> Customer Product Information (CPI)

No.: PN21-066

Datasheet drawing unification of SEMIPACK 2 modules

Subject of change: SEMIPACK 2 datasheet drawing

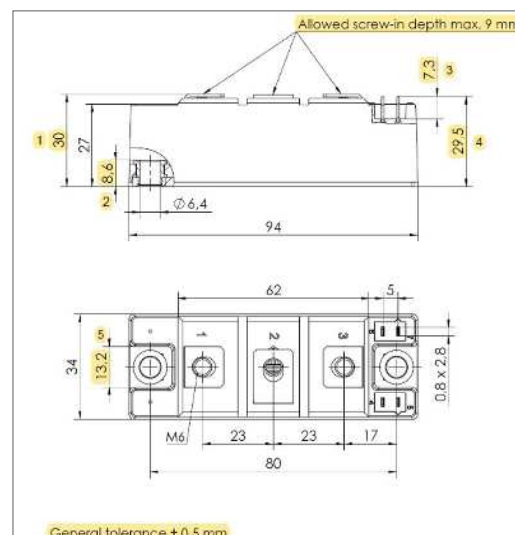
Errata of datasheet drawing and addition of general tolerance in some SEMIPACK 2 data sheets

- 1) old $30^{+0.2}\text{mm}$ → new 30mm with general tolerance
- 2) old 8.3mm → new 8.6mm
- 3) old 6mm → new 7.3mm
- 4) old 29mm → new 29.5mm
- 5) old 13mm → new 13.2mm

The dimension of terminal hole depth is replaced by maximum screw-in depth
